SUNDRY NOTICES AND REPORTS ON WELLS

HORSESHOE GALLUP #82

Re: Permanent Abandonment
Well: 82 Horseshoe Gallup Unit

CONDITIONS OF APPROVAL

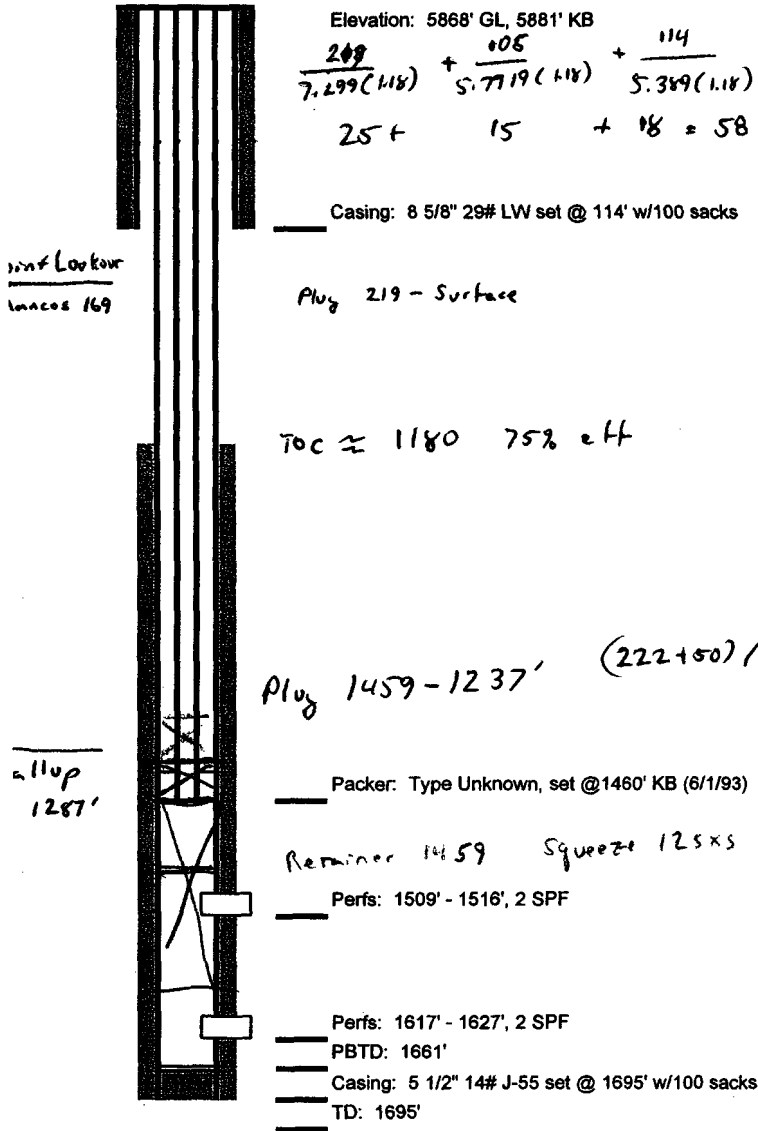
1. Plugging operations authorized are subject to the attached "General Requirements for Permanent Abandonment of Wells on Federal and Indian Lease."
2. Mike Flanikan with the Farmington Office is to be notified at least 24 hours before the plugging operations commence (505) 599-8907
3. The following modifications to your plugging program are to be made:
 - a) Bring the top of the Gallup plug to 1237'.
 - b) Set surface plug from 219' to surface inside and outside the 5 1/2" casing to cover the Point Lookout.

- BLM geologist's pick for the top of the Gallup fm. reflects the top of the transitional Tocito interval in this well. This top varies from operator's pick in this well.
- It is recommended that the Gallup top in this report be adequately covered with cmt.
- In addition, it is recommended that the surface plug be extended downward to cover the top of the Mancos fm. This will isolate and protect potential fresh or useable water sands in the Point Lookout fm.
